**Project Name:** \* Bridge 9 over South River on US 13

B-4635

Subject: **Request for Additional Information for T.I.P. B-4635 (Replacement of Bridge 9 over South River Overflow on US 13, Sampson County)**

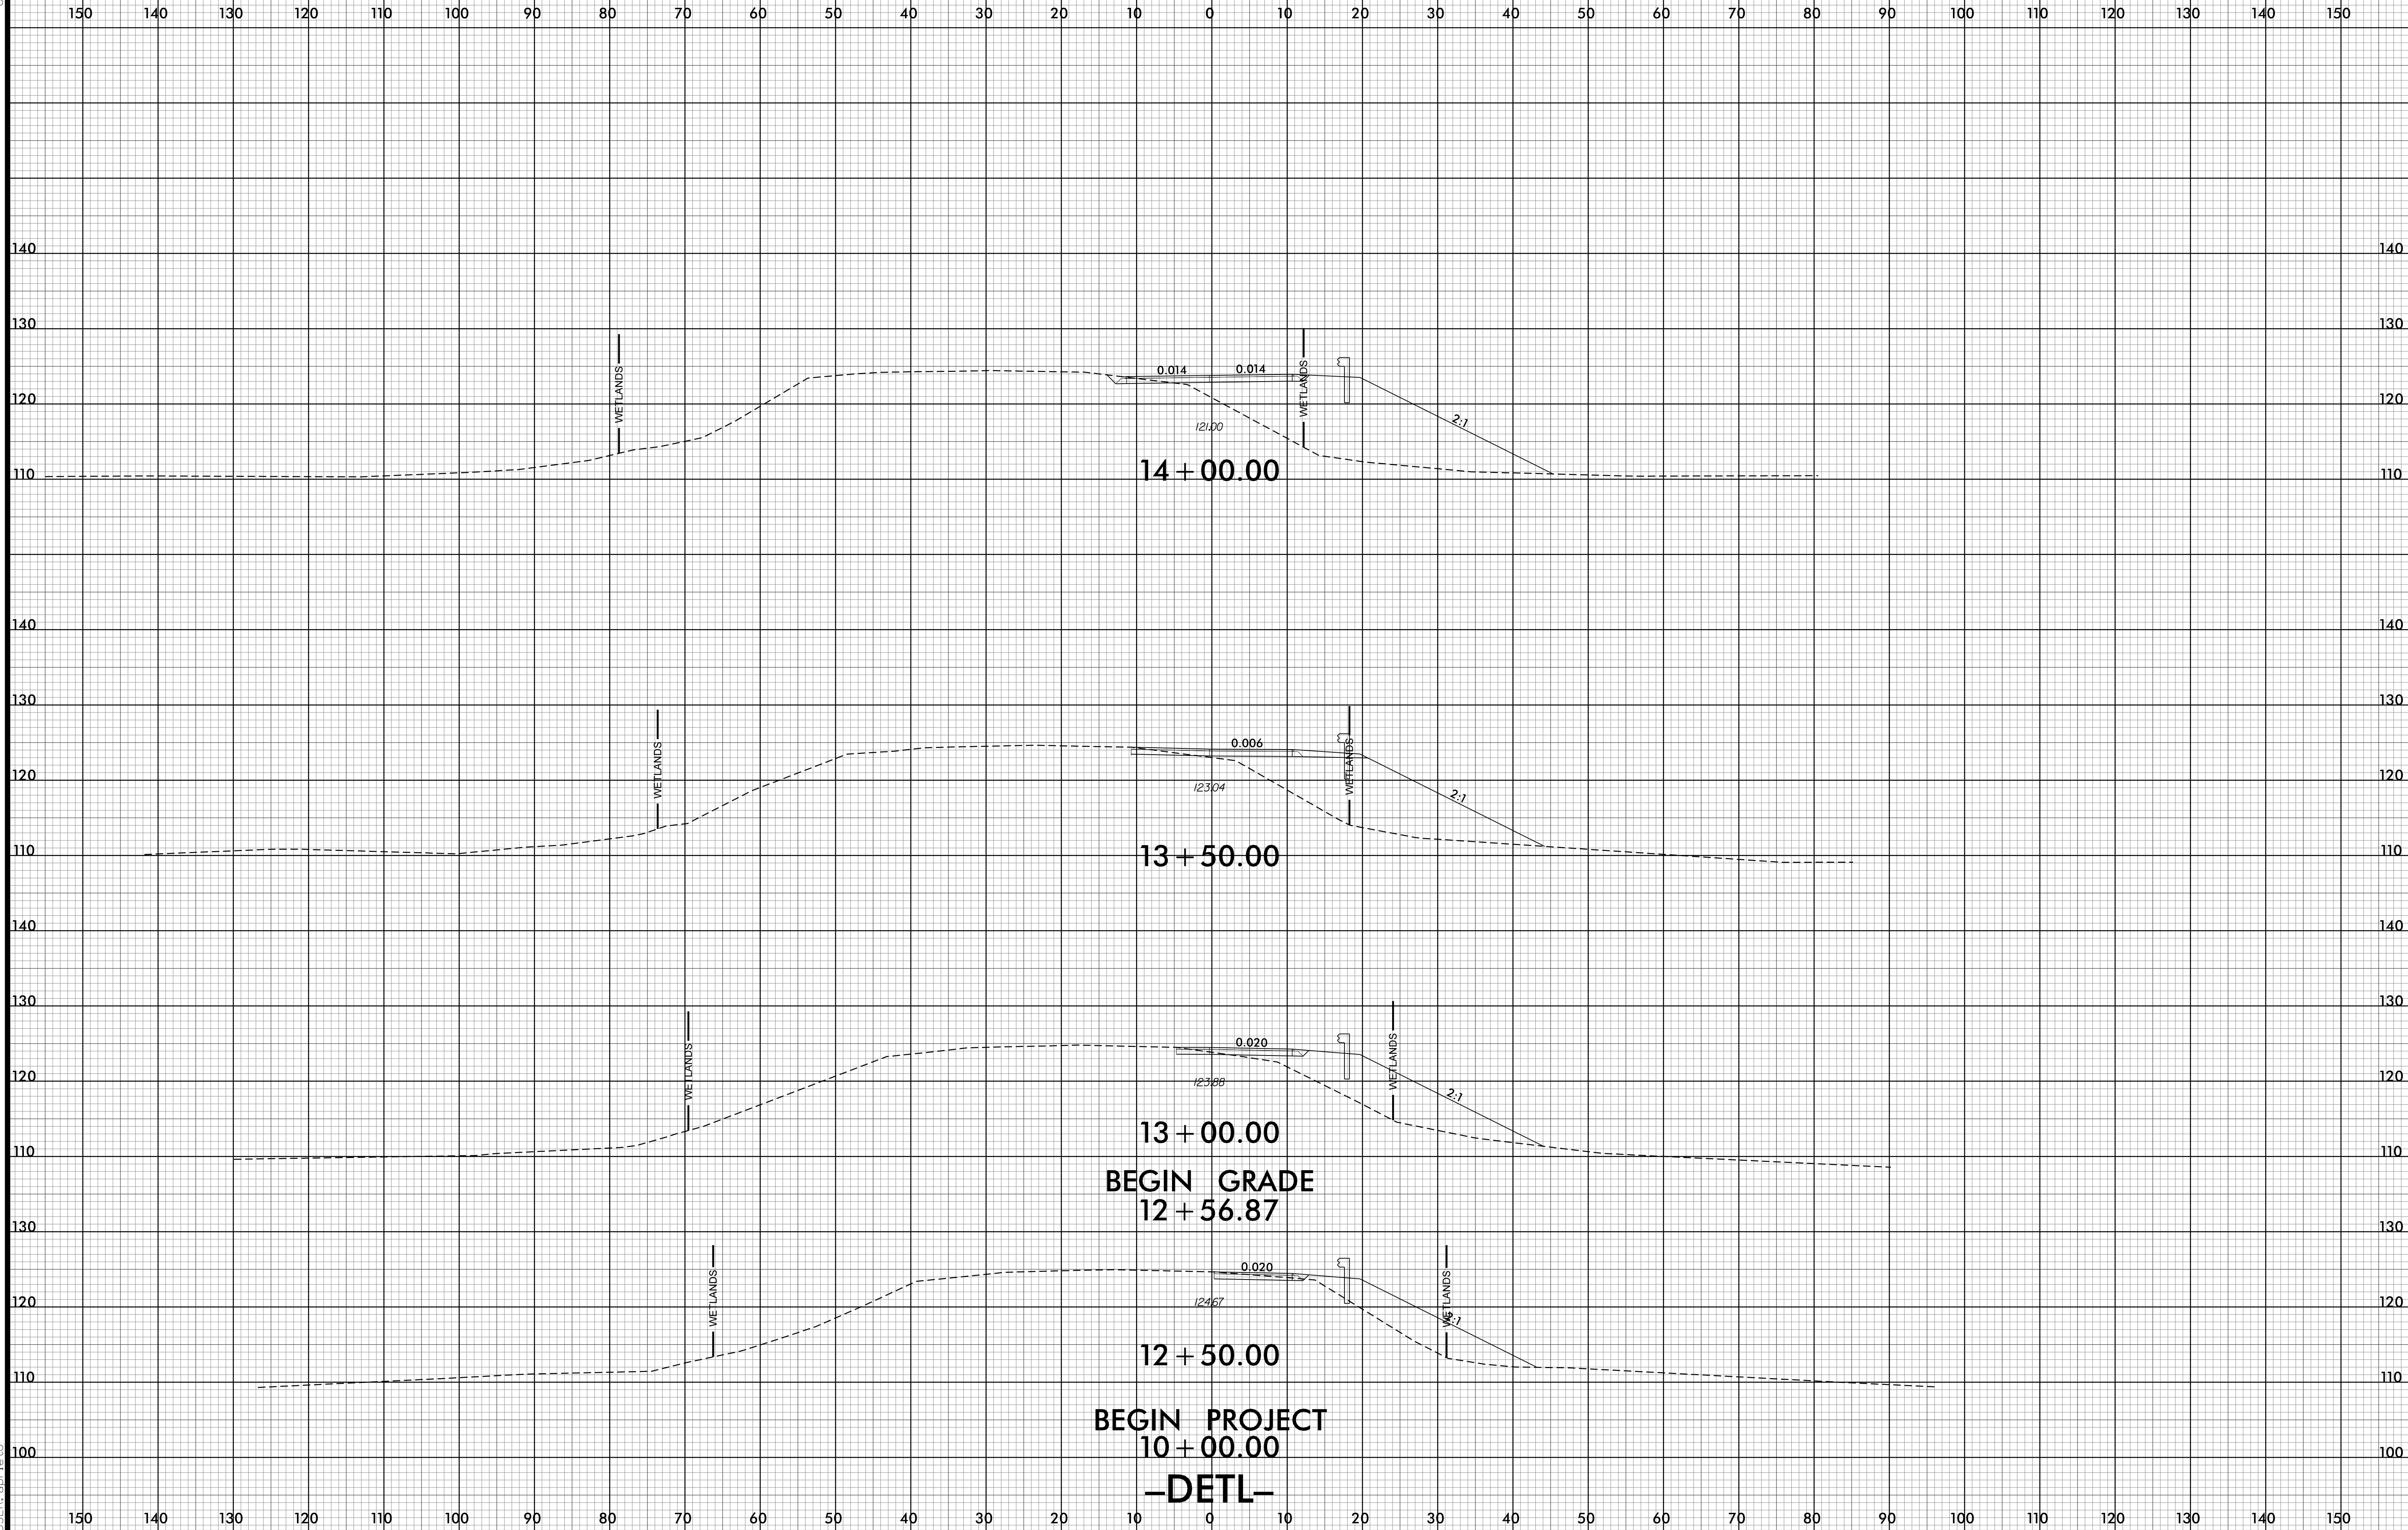
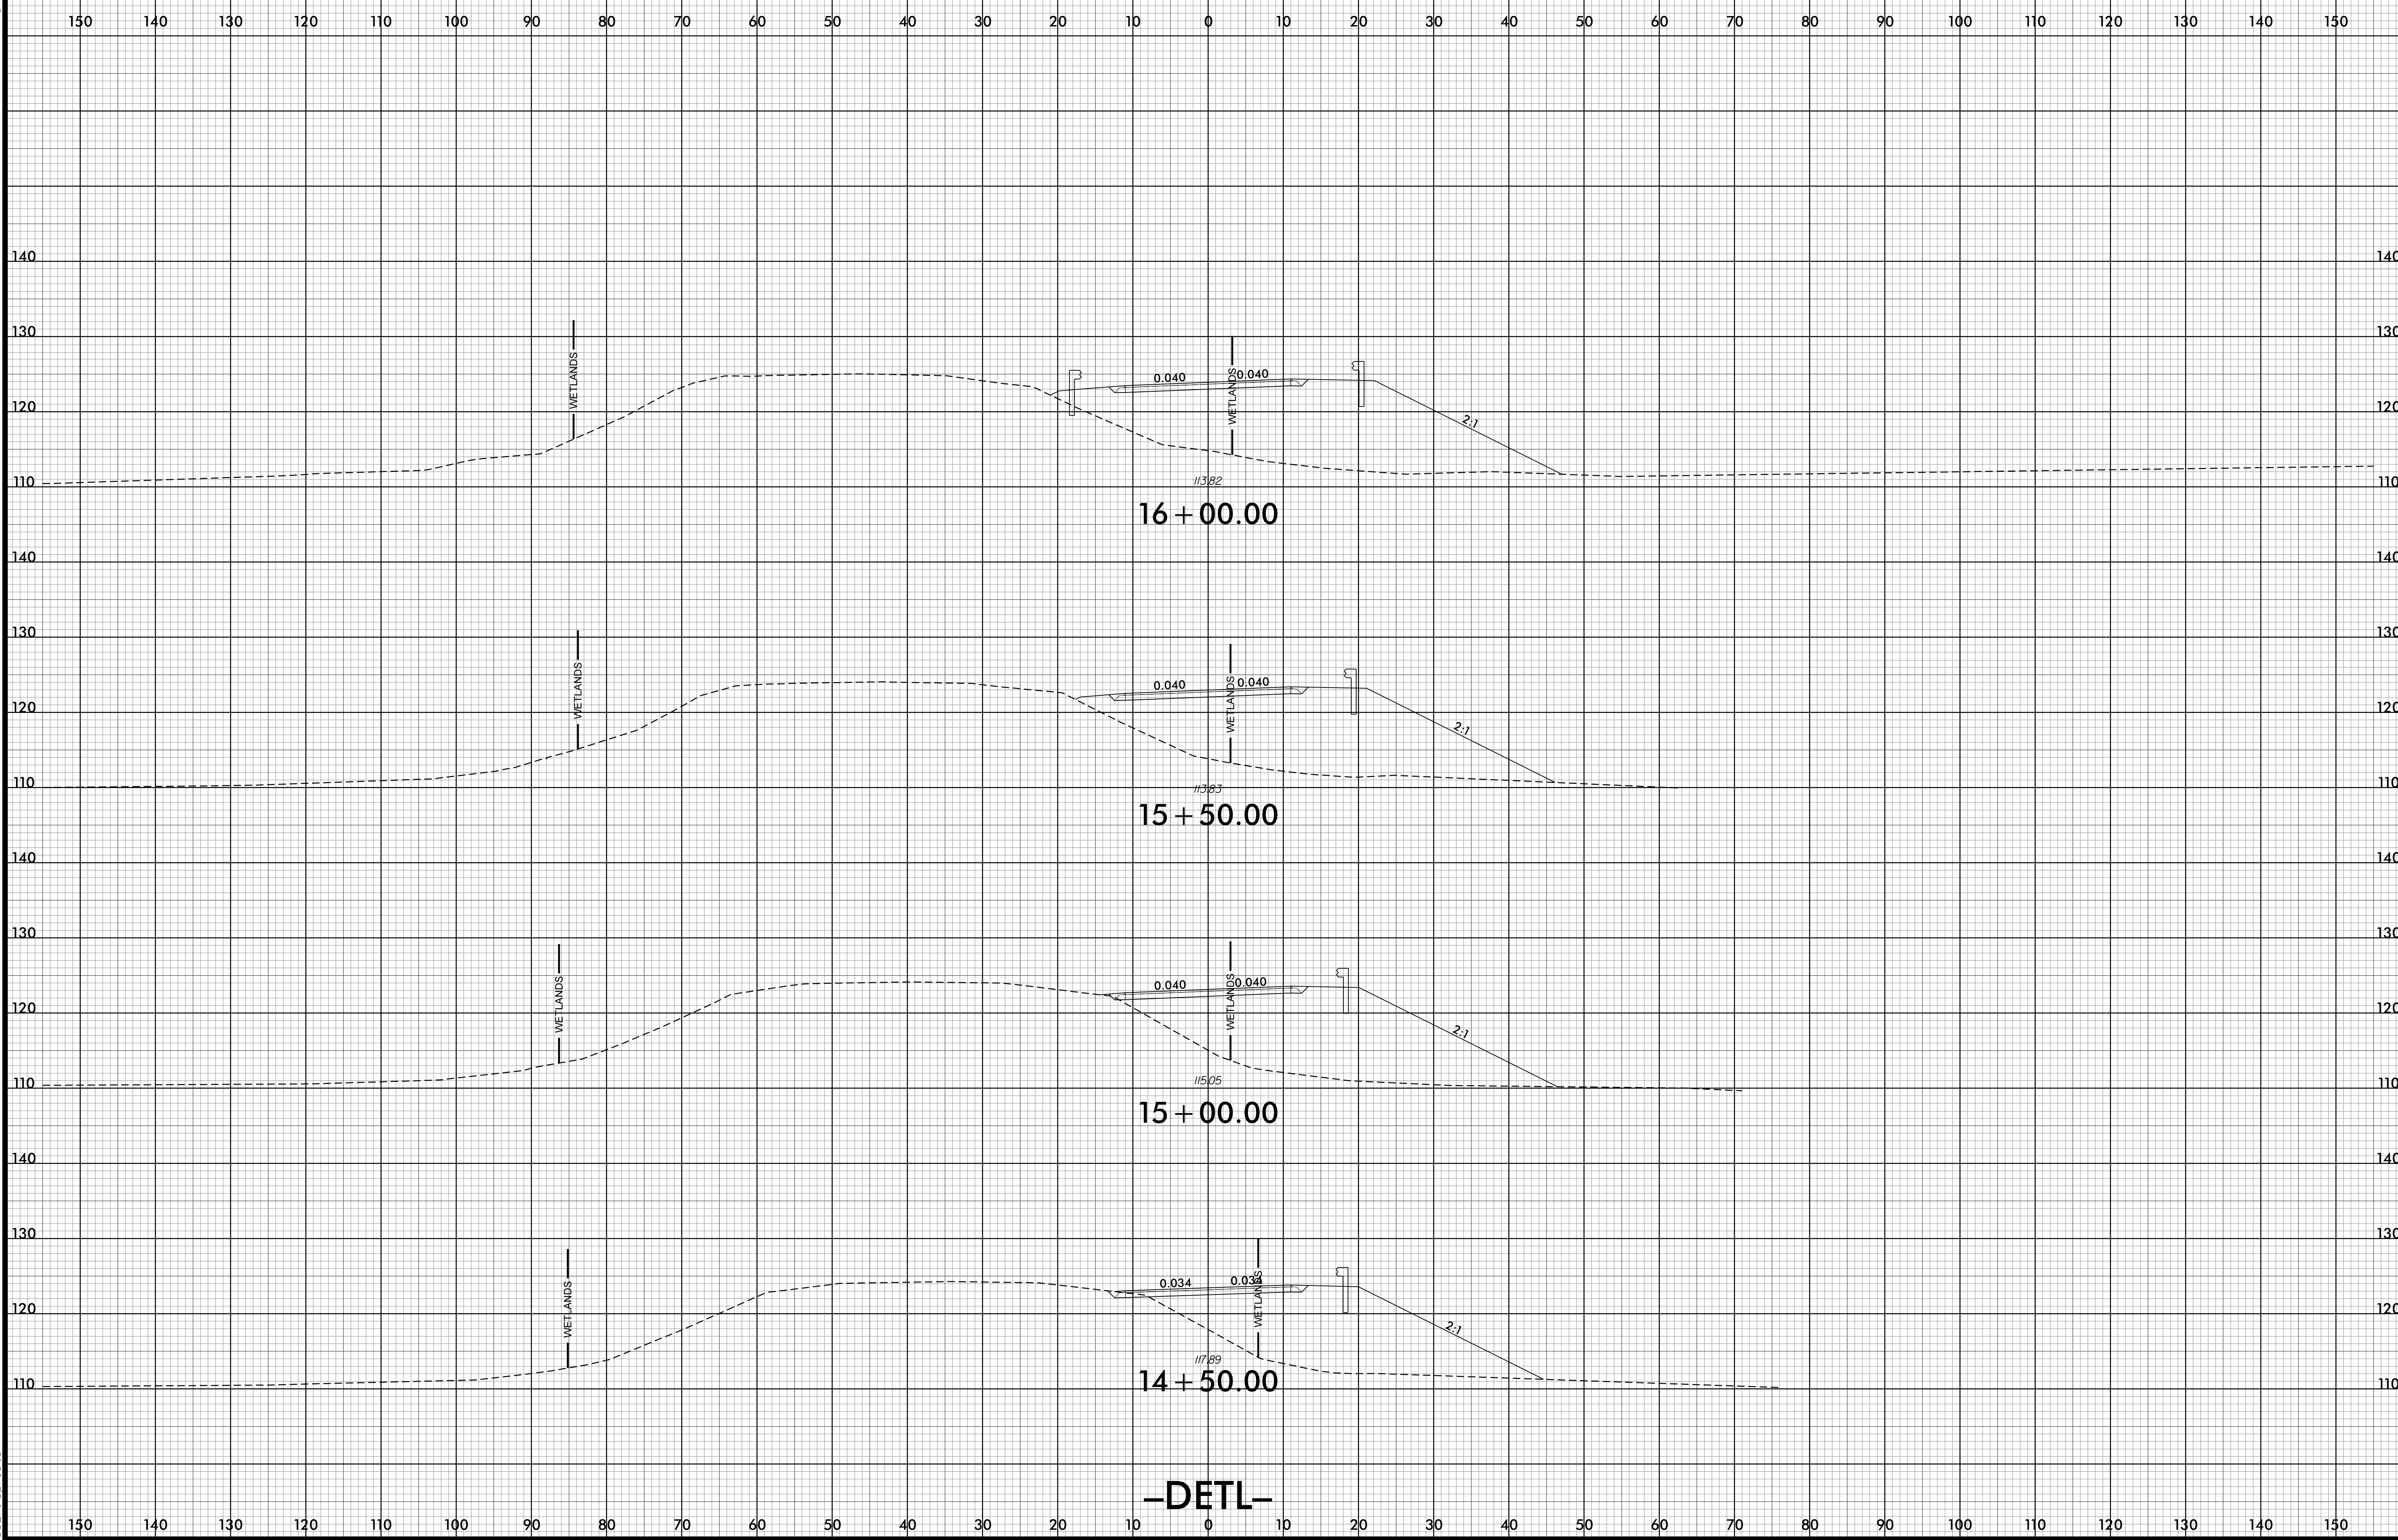
-there is no slope listed in the cross section drawings regarding the temp detour which leads to the question, could the slope be steeper than 3:1 since it would most likely be constructed with a rock base thus reducing the amount of temporary impact? **Cross sections of the detour are included in revised drawings to show 2:1 slopes along the detour.**
